SITE INSPECTION SHEET

OWNER: Kamhran Zangna PHONE #: 301-225-3380
ADDRESS: 11471 Harding Rd. CONTRACTOR: _____
WELL TAG #: _____
SUBDIVISION: _____ LOT: _____ COUNTY #: _____
PROPOSAL: Owner considering converting a well to irrigation well.

HOWARD COUNTY DEPARTMENT OF HEALTH

LOCATION DIAGRAM

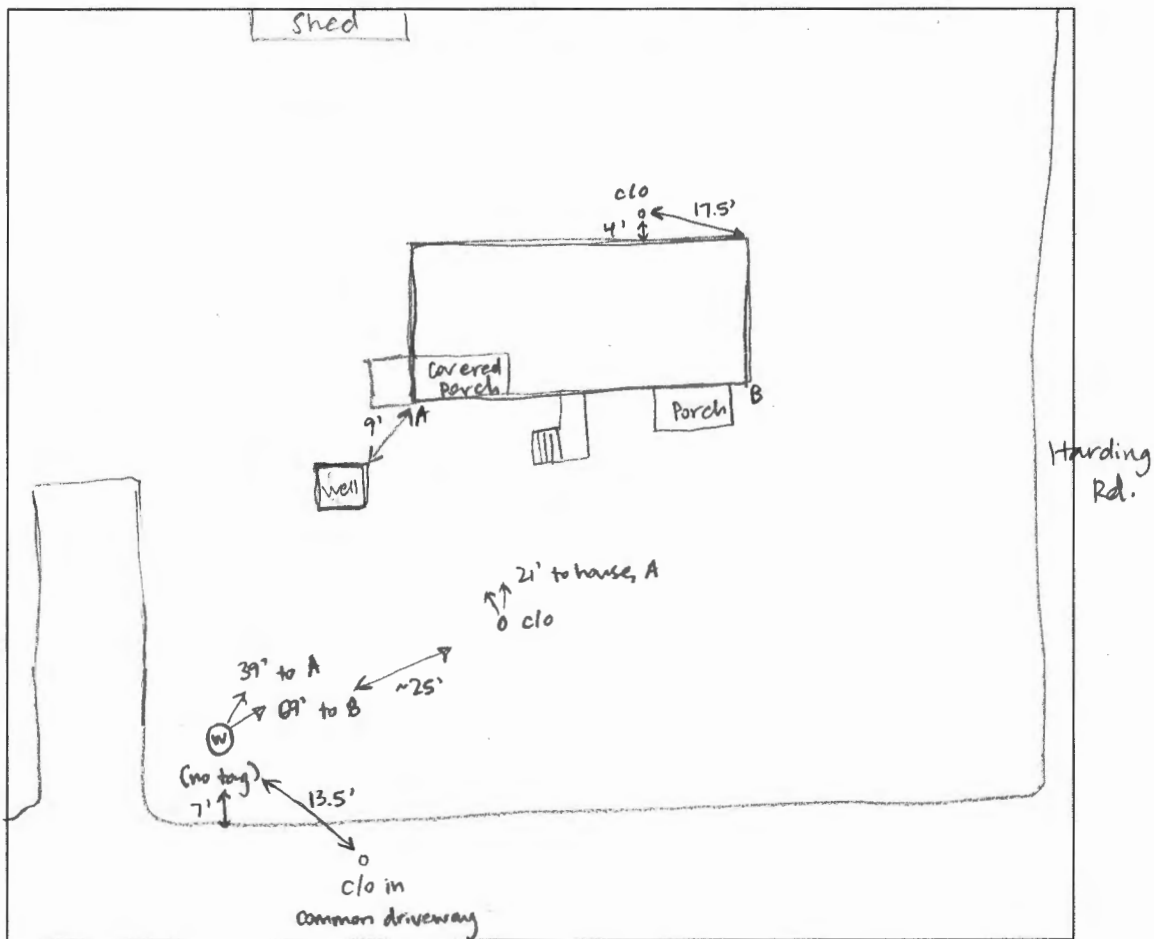
COMMENTS: Property owner says house is connected to public water + sewer. He is considering keeping one well for agriculture if it's cheaper than abandoning. Hand dug well is 4' diameter, 35' deep per owner. Hand dug well must be sealed. Drilled well can be kept if conditions in attached memo are met.
